GSM TAICHI TRANCEIVER
P/N 8464373E03
SHEET 1 (LCD)

DualBand Tai Chi_8464373E03 REV B (P12)

GSM SERVICE SUPPORT GROUP	29.03.00
GSM / DCS SELECT CIRCUIT	Rev. 1.0
Organizer Dualband Tai Chi	8464373E03 Rev B (P12)
Michael Hansen, Ralf Lorenzen, Ray Collins	Page 1

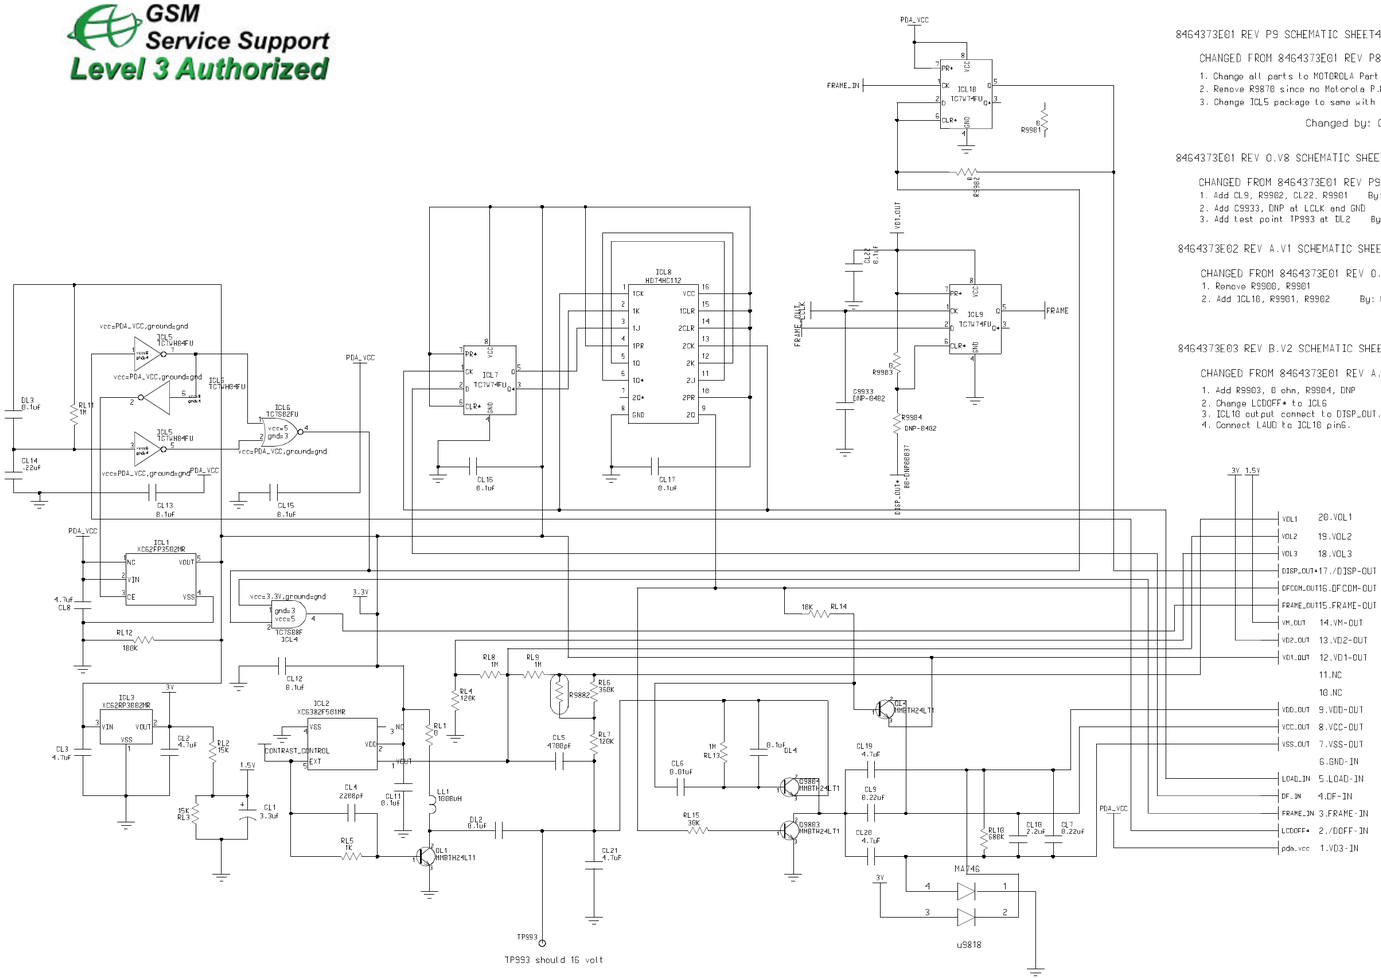
CHANGED FROM 8464373E01 REV P8

1. Change all parts to MOTOROLA Part No.
2. Remove R9870 since no Motorola P.N
3. Change ICL5 package to same with ICL7 package

CHANGED FROM 8464373E01 REV P9

1. Add CL9, R9902, CL22, R9901 By: CC Wang
2. Add C9933, DNP at LCLK and GND By: Bob Huo
3. Add test point TP993 at DL2 By: CC Wang

CHANGED FROM 8464373E01 REV O.V8

1. Remove R9900, R9901
2. Add ICL10, R9901, R9902 By: CC Wang

CHANGED FROM 8464373E01 REV A.V1

1. Add R9903, 0 ohm, R9904, DNP
2. Change LCDOFF• to ICL6
3. ICL10 output connect to DISP_OUT.
4. Connect LAUD to ICL10 ping.
